# UNITED STATES PATENT AND TRADEMARK OFFICE

# Office Action Summary

10/711,913

## DETAILED ACTION

**FIG. 2**

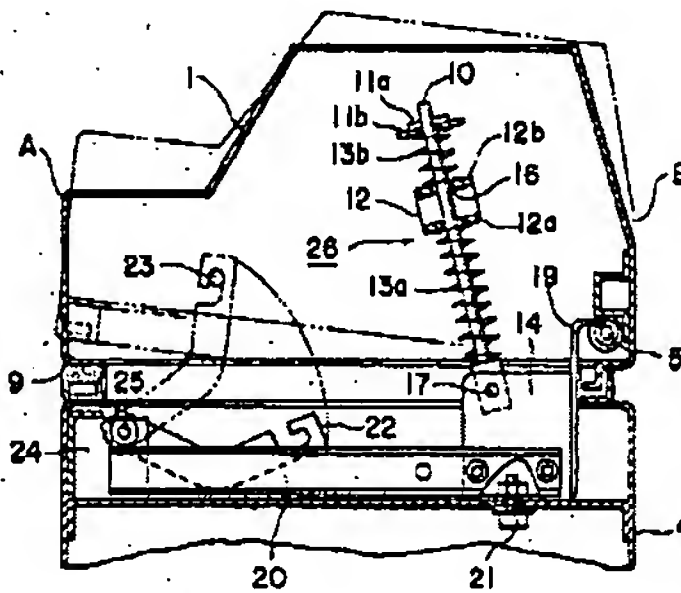
- {claim 1} A machine body (figure 2); a housing (figure 2); an upper body capable of being positioned at a range of angles relative to the housing (figure 2, reference 1); and a hinge (figure 2, reference 5) comprising a support shaft (figure 2, reference 10) connected to the upper body; and a support block (figure 2, reference 12) connected to the housing, the support block comprising a hole (figure 2, reference 16), and the support shaft passing through the hole (figure 2, reference 10) and capable of moving up and down along the hole (column 1, lines 43-47)

- {claim 2} wherein the support block is rotatably connected to the housing (figure 2, reference 12)
- {claim 3} wherein the hole is a cylindrical hole and the support shaft is a cylindrical shaft (figure 2, reference 10, 16)

- {claim 4} wherein the area of the cross section of the support shaft is constant over the length of the support shaft (figure 2, reference 10)
- {claim 7} wherein at least one section of the support shaft tightly fits the support block (figure 2, reference 10, 12)

- {claim 11} wherein the support shaft comprises a cylindrical shaft and wherein the hold comprises a cylindrical hole (figure 2)
- {claim 25} An apparatus comprising: means for coupling an upper body to a housing, wherein the means for coupling comprises means for connecting a support shaft to the upper body, and means for supporting the support shaft, the means for supporting connected to the housing, wherein

the means for supporting defines a hole, the support shaft passing through the hold and capable of moving through the hole, wherein the upper body is capable of being positioned at any of a range of angles relative to the housing due to friction between the means for supporting and the support shaft (figure 2)

- {claim 26} further comprising means for rotatably connecting the means for supporting to the housing (figure 2)
- {claim 27} wherein the hole comprises a straight hole and the support shaft comprises a straight shaft (figure 2)
- {claim 28} wherein the hole comprises a straight cylindrical hole and the support shaft comprises a straight cylindrical shaft (figure 2)
- {claim 29} wherein the area of the cross section of the support shaft is constant over the length of the support shaft (figure 2)

The examiner respectfully disagrees. There are inherently friction forces between the support shaft and the support block. Furthermore, the upper body is clearly disclosed as capable of being positioned at any of a range of angles, as shown in figure 2 and the abstract. While it is true that the upper body is not being positioned exclusively by friction force (i.e. a spring assists in the process), this does not change the fact that the friction force does play a role in the positioning of the upper body. The claim limitations do not exclude the assistance of the spring in addition to friction force.
